# PLANNING DIVISION STAFF REPORT

November 22, 2021

**Project Address:** 341 State Street, 315-321 W Gorham Street and 322 W Johnson Street

**Application Type:** Zoning Map Amendment, Demolition Permit and Certified Survey Map Referral

**Image 5: Proposed Building Height of the 10-Story Oliv Madison Building (Left) vs. Maximum Building Height Allowed by Sec 28.071(3)(d) for an 8-Story Building (Right).**

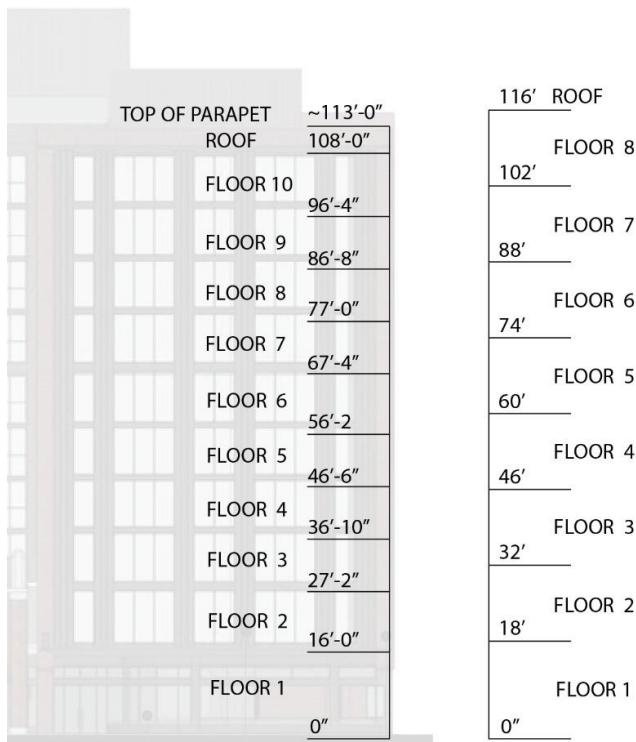
So while staff believes that it is possible that the proposed height could be found compatible with the existing character, the Downtown Plan recommends eight stories where 10 are proposed. As shown in Image 5 on page 7, the applicant's utilization of shorter floor-to-floor heights brings the resulting height to a similar height to what would be allowed if the maximum floor-to-floor heights were utilized. However, the Downtown Plan recommends that buildings with lower floor-to-floor heights should reduce the number of stories accordingly.
